MODELS DV5932H DV5935H DV5937H DV6635H

Location of PWB

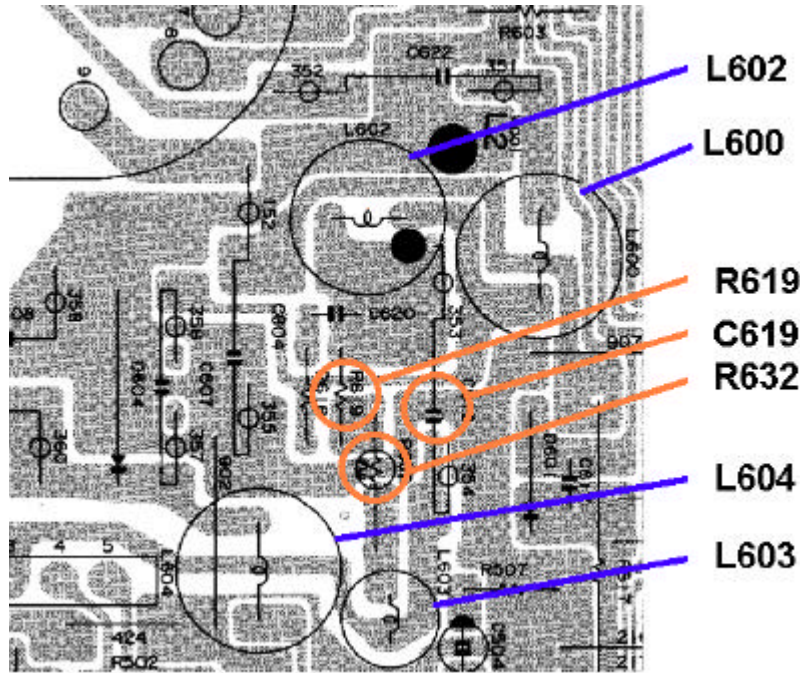
SYMPTOM In some instances it is possible for C619 and associated line scanning coil earth return components to fail. This may result in a hole being burnt in the PWB.

CAUSE Failure of L603 and C619.

- 1) Remove R619, R632 and C619 from the PWB.
- 2) Clean the PWB in the area of the above components (remove any carbonised material as necessary).
- 3) Fit PWB (DUNTK7297BMZZ) in the place of R619, R632 and C619 as show in the diagram on below. Note that this PWB comes with a nut and bolt so that it can be mounted on the vertical output IC heat sink.
- 4) Replace L600, L602, L603 and L604.
- 5) Reflow all solder joints on the scanning coil PWB.

Component Locations on Mother PWB

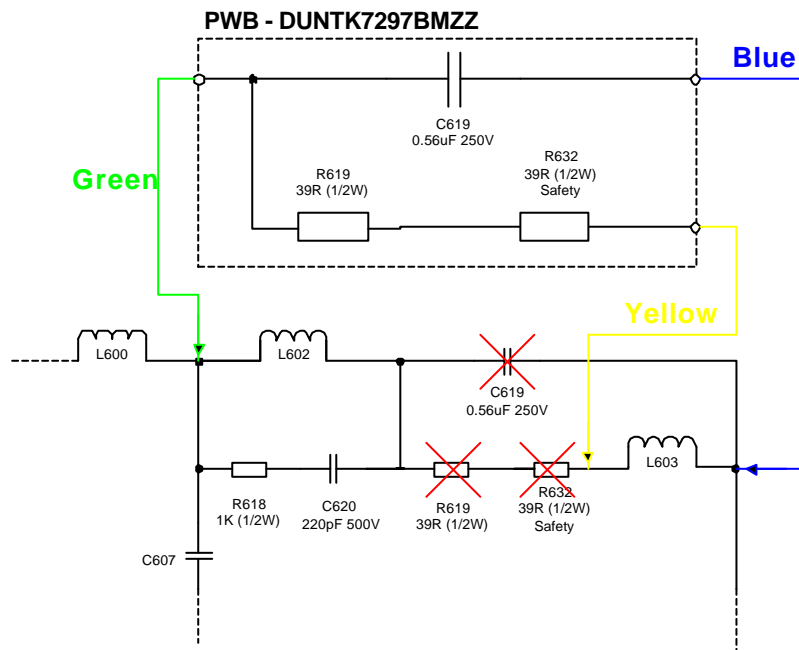
Connection of PWB – Note that C619, R619 and R632 must be removed from the Mother PWB before connecting PWB DUNTK7297BMZZ
